**970 Walker Street: Rezoning Application No. 00826 and Development Permit with Variances Application No. 00214 (Vic West)**

## Committee of the Whole Report For the Meeting of August 3, 2023

**Subject:** **Rezoning Application No. 00826 and Development Permit with Variances Application No. 00214 for 970 Walker Street**

**VARIANCE:  
 WINDOW ON 1.5m SETBACK  
 ON HABITABLE AREA**

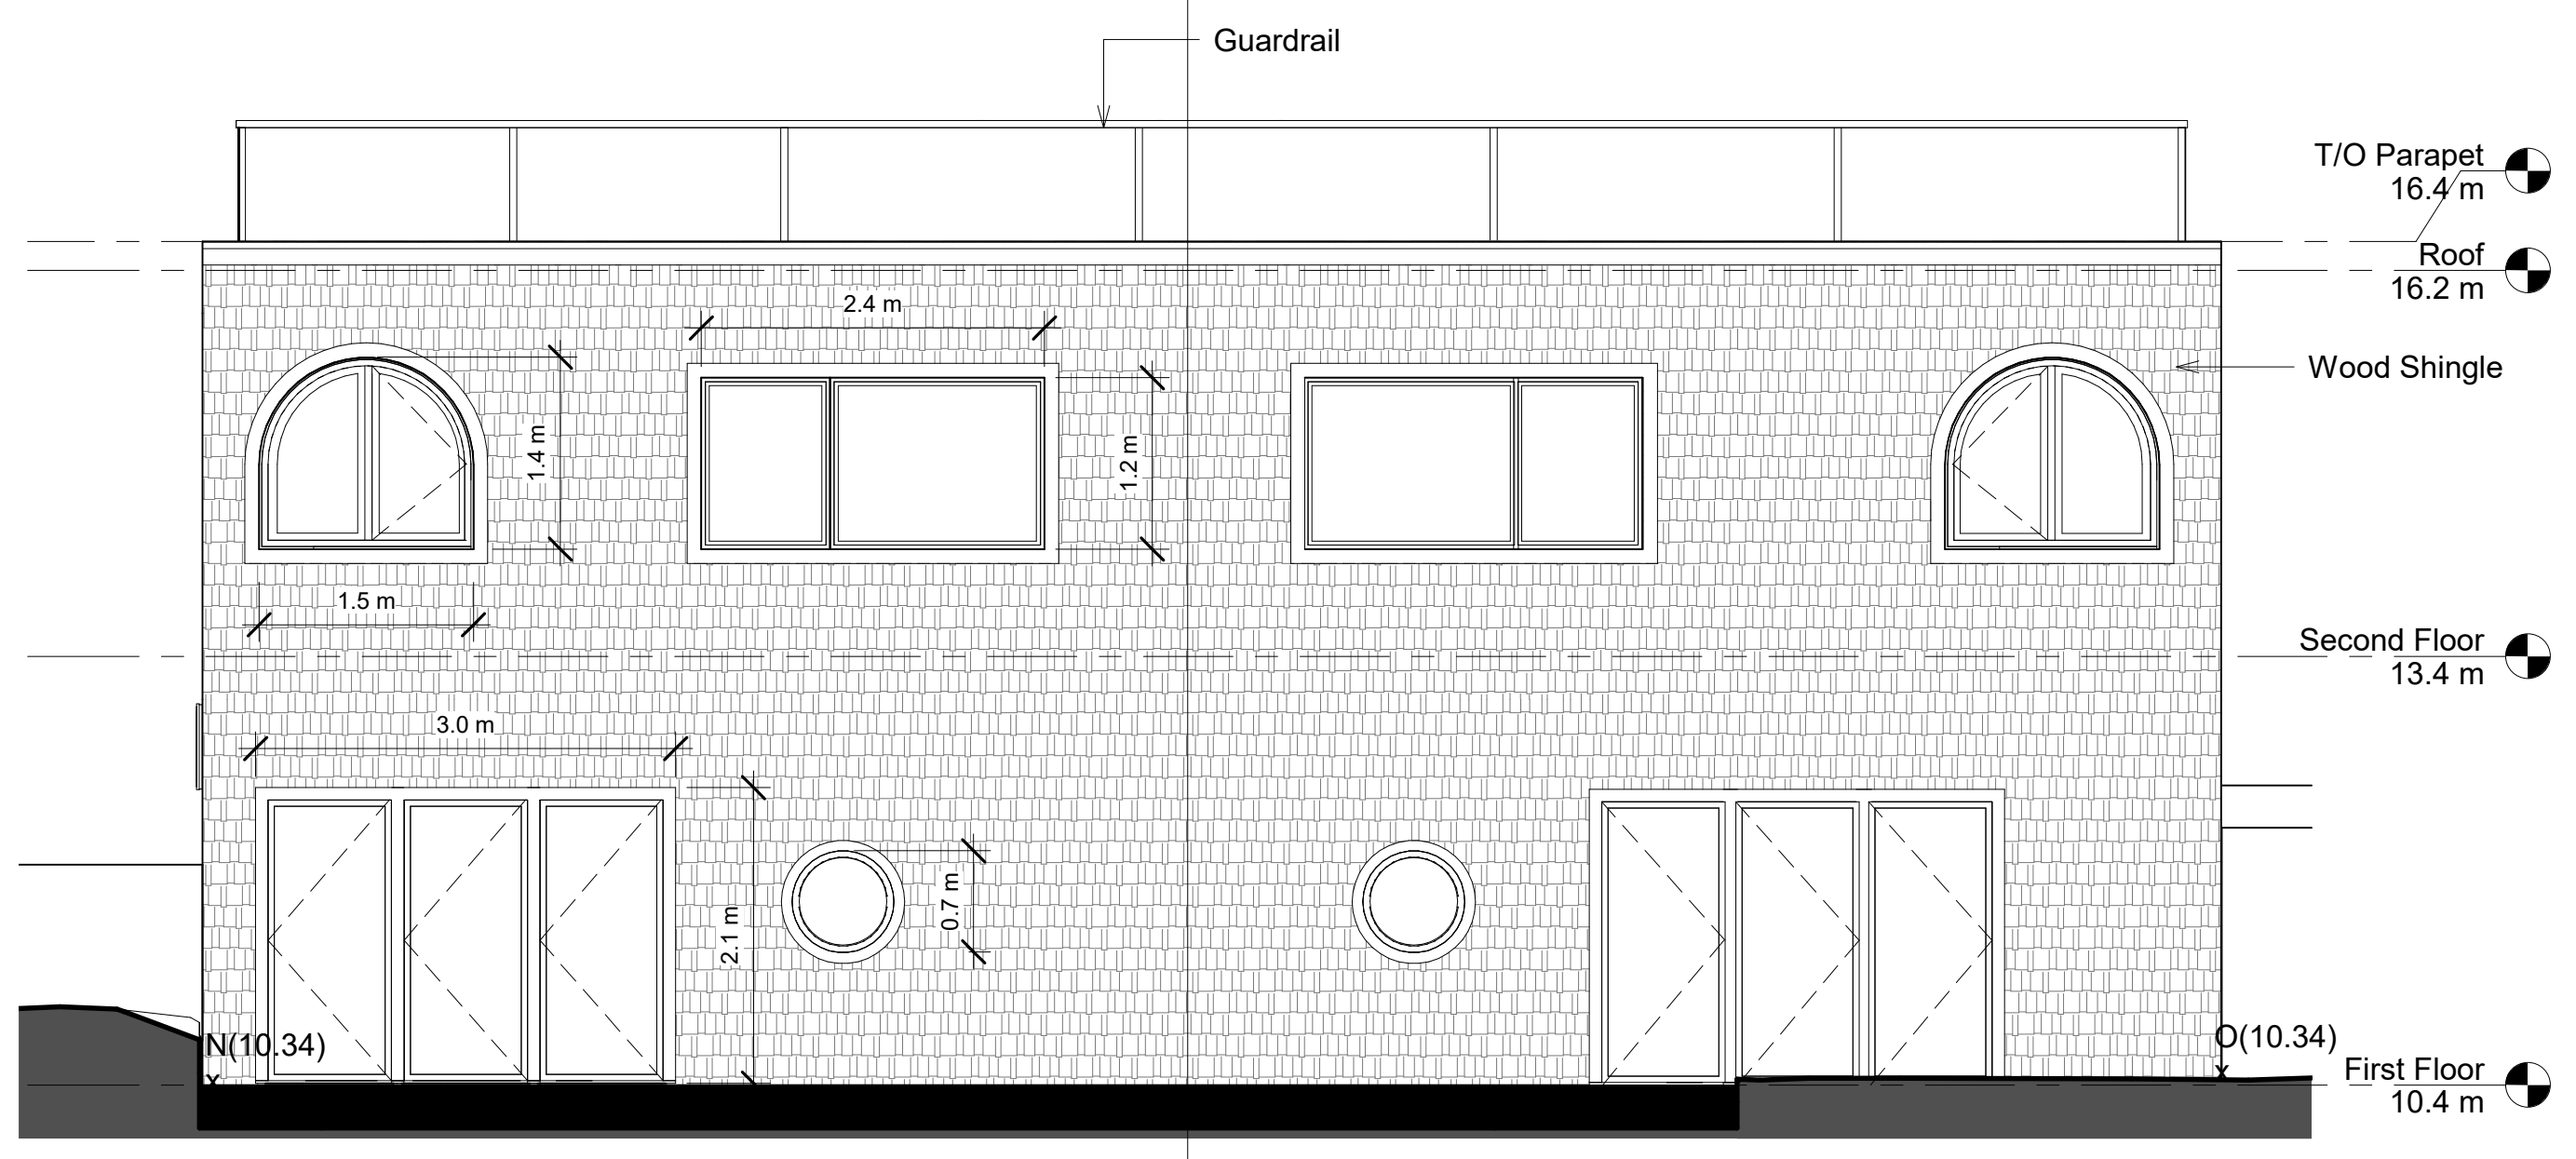
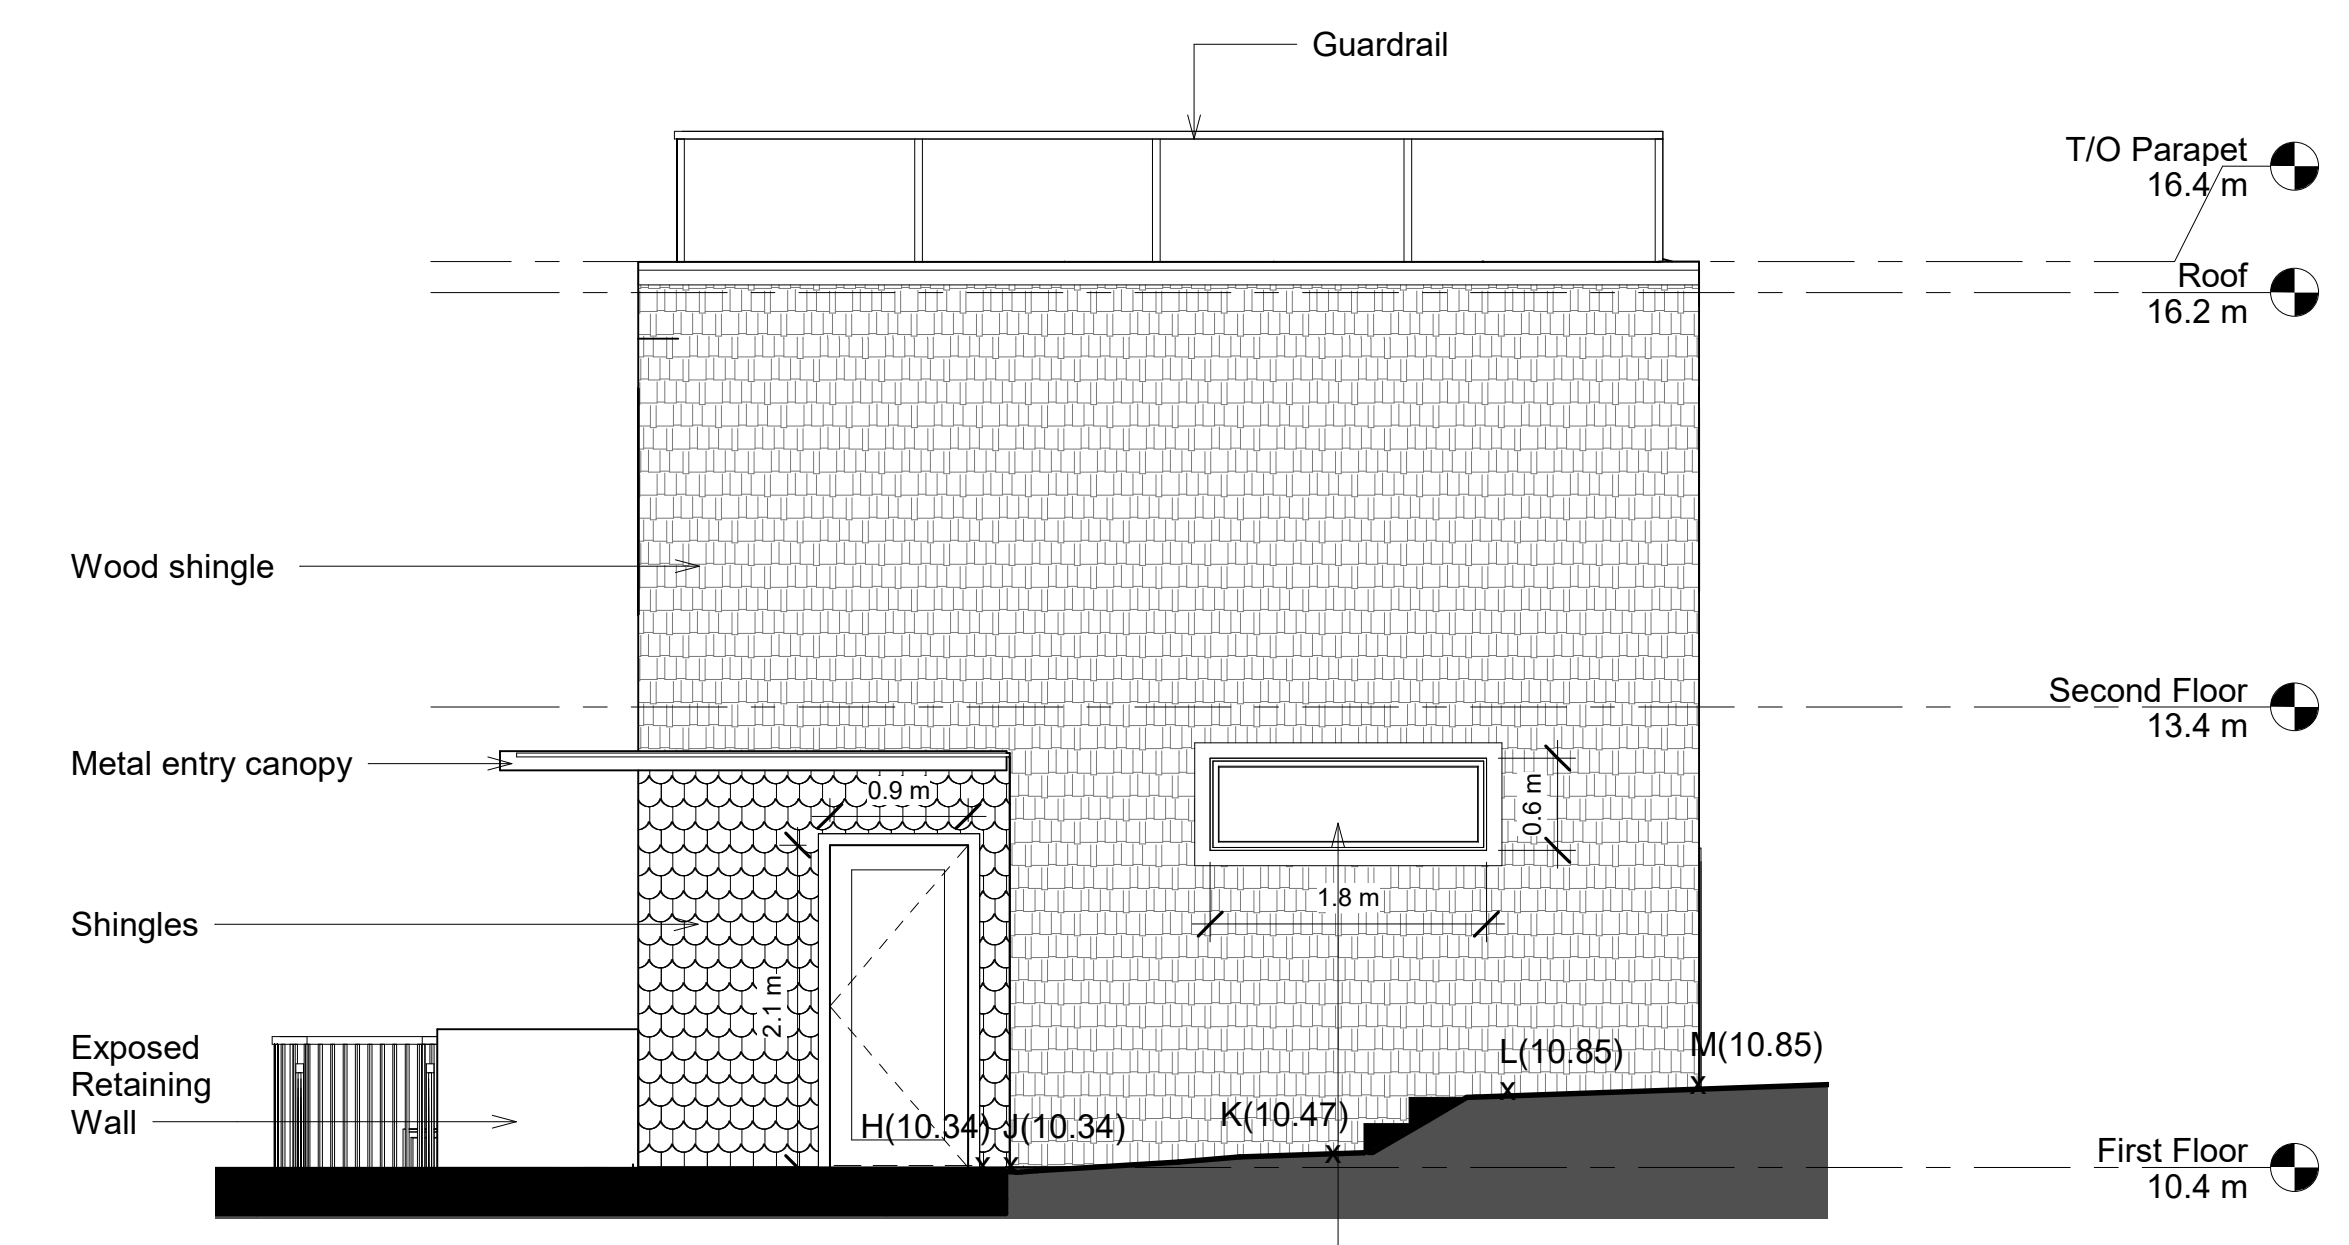
*The City requested further justification for 1.5 meter side yard setback variance with windows on habitable spaces. The 2 proposed clerestory windows on east and west elevations are modest in size (0.6m x 1.8m) and are strategically located high on the wall (sill height: 2.1 meters from the floor) to protect privacy and with the sole intent to bring in more natural light. The inclusion of these windows would add to comfort and quality of space.*
